ERC Series Remote Condenser - Horizontal Coil Type

Bulletin Number: PS - 3 - 98

SERVICE BULLETIN

Subject: ERC301 Fan Motor

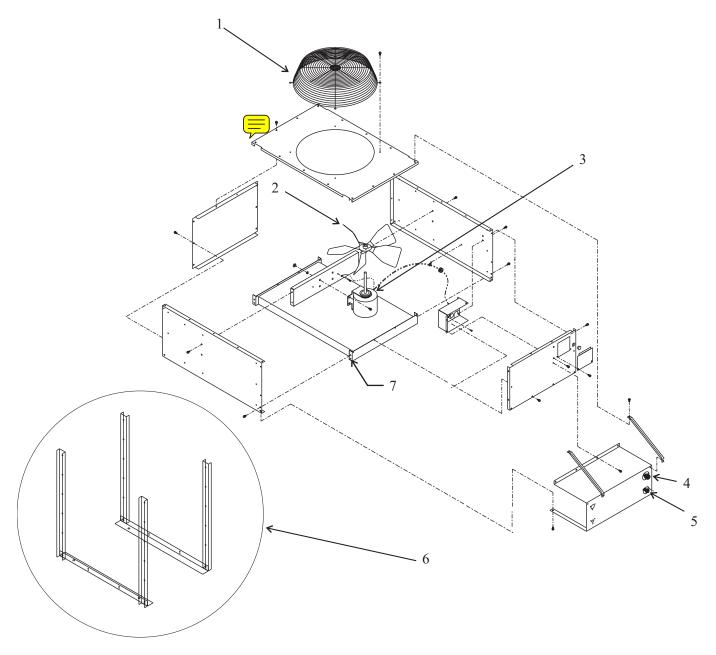
Effective with serial number 103236-10B, the ERC301 remote condenser is being manufactured with a one-third H.P. fan motor instead of the prior one-quarter H.P. motor.

The part number for the new motor is: 18-8797-32.

Although the ERC301 is the only condenser manufactured with the one-third HP fan motor, the 18-8797-32 motor will be used as a common replacement for ERC151, ERC201, ERC302, ERC401, and ERC402 fan motors.

Note: Fan motors shipped and ERC301 condensers built after 11/1/98 have a shorter shaft. The fan blade mounts flush to the end on those motors. A quick check is that the "flats" on the motor shaft are now 1%" long and they were 2 ½" long. When the longer shaft one-third HP motor is used, position the fan blade 7/8" in from the end of the motor shaft.
